DELEGATED APPLICATION REPORT

App Ref: PL/25/1023 – application for full planning permission

Address: Kennet Place, 121 Kings Road, Reading, RG1 3ES

Proposal: Replacement of windows/doors on all elevations at ground floor level; installation of balconies on east, south and west elevations at ground floor, north elevation at 1st to 3rd floors and west elevation at 2nd floor level; installation of projecting smokeshafts and automatic opening vents at roof level; and, various associated alterations.

Right: Extract of proposed roof plan

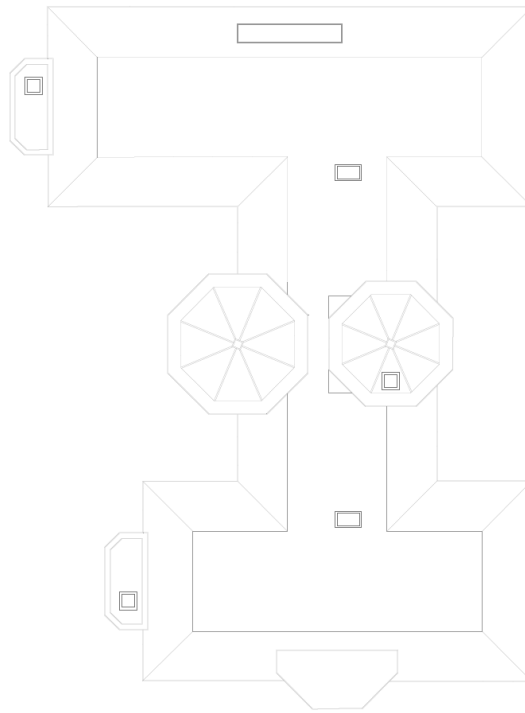
At roof level, the previously approved AOV vents and smoke shafts were not anticipated to project from the roof level, thereby not having any material visual impact. However, separate building regulations requirements have confirmed that there is now a need for a slight projection to be provided. These are consequently shown on the plans. Whilst such additions would now have a material visual impact, this impact is not considered harmful in the context of the building as a whole or the wider character of the area. These additions are relatively modest, will not be highly discernible in the street or river scenes and serve an important function in delivering the overall development at the site.

During the design development, and in accordance with the statutory building regulations, it was noted that these rooftop smoke vents and AOVs must project a min. of 500mm above any surrounding structure within 2m of them. This therefore has meant that the head of these elements may now be visible on the elements, even if only slightly. They have been included on the elevations accordingly.

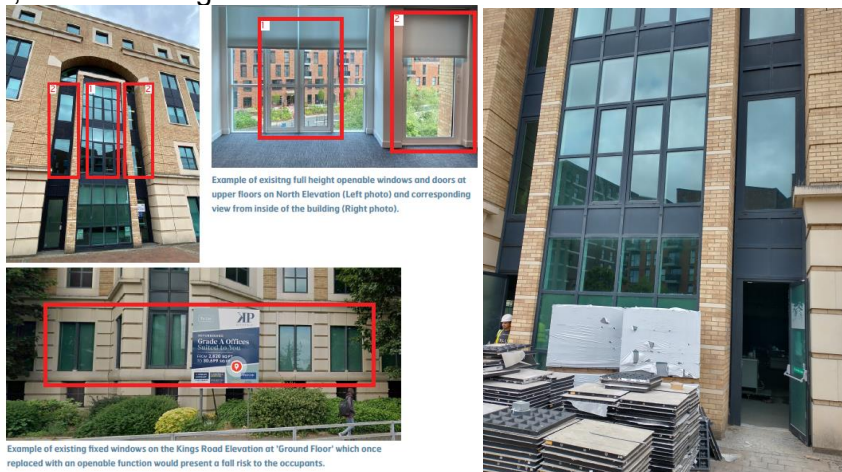
2. Proposed Ground Floor Openable windows/doors

All existing ground floor windows are fixed, which is common in office use where the building is fully mechanically ventilated.

As these windows now serve residential units, the proposal is to replace these fixed windows with openable tilt and turn windows or inward turning balcony doors.

In scenarios where these new openable elements are elevated from the external ground level (however still at building ground floor) as either a tilt and turn window or door, this would present a fall risk.
It is therefore the proposal to add a Juliet balcony to any 'elevated' full height operable units at ground floor.

Photo of existing raised planter with benching

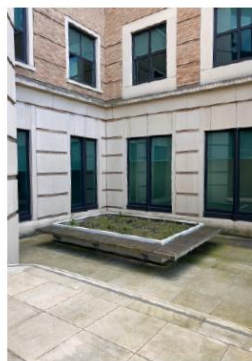
Externally, within the forecourt area of the western elevation, fronting onto Forbury Road, it is proposed to remove the two existing raised planters / benches and provide like-for-like paving to match that surrounding the planters. This raises no design-based concerns, with future occupiers of the corresponding flats possibly being able to utilise these resultant spaces for amenity purposes. The proposed replacement balustrade

Either side of the main entrance to the building, on the Front Elevation to Forbury Road, there are 2no. existing raised planters with integrated timber benching.

See photo opposite. The planters are currently bare and unattended to.

It is very unlikely this space will be utilised by residents, with an additional concern that benching may as a place for loitering for those not associated with the building.

The proposal is to remove these planters, and replace them with paving stones to match existing.

This will create the for small private terrace areas for the flats directly serving them at ground floor.
